# UNITED STATES PATENT AND TRADEMARK OFFICE

APPLICATION NO.	FILING DATE	FIRST NAMED INVENTOR	ATTORNEY DOCKET NO.	CONFIRMATION NO.
10/055,083	01/25/2002	Terry Chou	12675 B	8107

**Office Action Summary**

## **DETAILED ACTION**

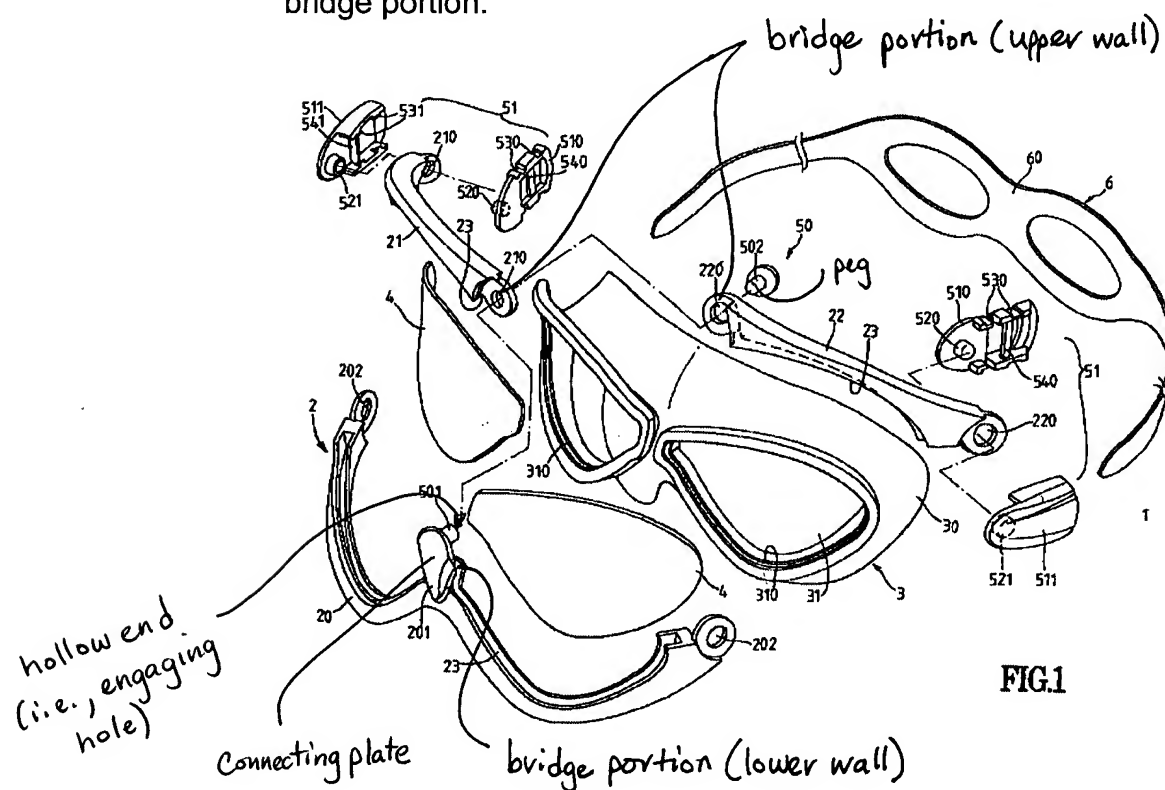
Chiang discloses a lens/frame assembly for swimming goggles having a frame 2 made of a rigid material with slight flexibility and a lens holding compartment 23 having a bridge portion (see figure below) in the middle thereof. The bridge

portion has an upper wall and a lower wall. Two lenses 4 are tightly received in the lens-holding compartment 23 of the frame 2. A connecting block 201 is securely received in the bridge portion of the lens-holding compartment 23 and securely mounted to the frame 2 to thereby securely retain the lenses 4 in place. The connecting block 201 connects the upper wall and the lower wall of the bridge portion.

With regard to claims 8 and 17, the bridge portion of the frame 2 comprises two engaging pieces 502 respectively formed on an upper wall and a lower wall of the bridge portion. Each engaging piece 502 includes a peg, the connecting block comprises two engaging holes (see figure above) and each peg 502 extends through an associated one of the engaging holes of the connecting plate 201.
